Rezoning Transportation Analysis
Petition Number: Insert Zoning Petition #2021-046
General Location Identifier: 08705203

Date	Description
04-29-2021	First Review (EL&KP)

Transportation Summary

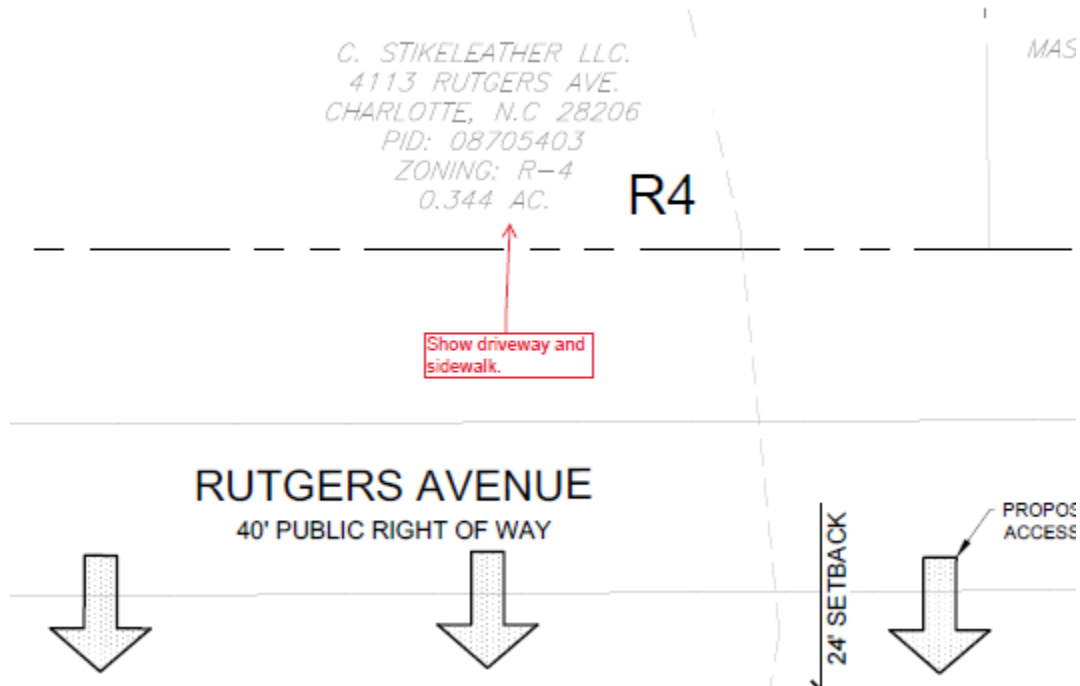
1. **Curb line:** The proposed zoning district has a setback measured from back of the existing or proposed future curb line.
 - a. **Rutgers Avenue:** The future location of curb and gutter will be located 13-feet from the existing centerline to back of curb.

Label and dimension the curb and gutter from the centerline.
